# SAFETY RECALL

**Mack Trucks Inc.**  
Greensboro, NC USA

Date	Number	Release	Page
12.2025	<b>SC0489</b>	<b>01</b>	<b>1(4)</b>

## **Load Lock Clamp PR**

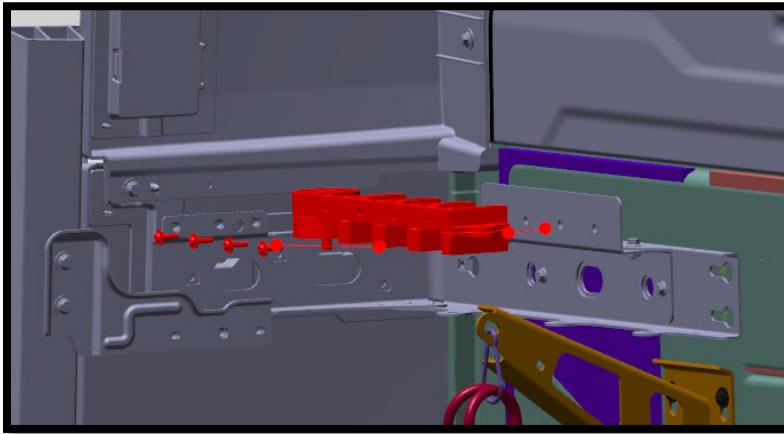
5. Locate the load lock clamp at back of cab.
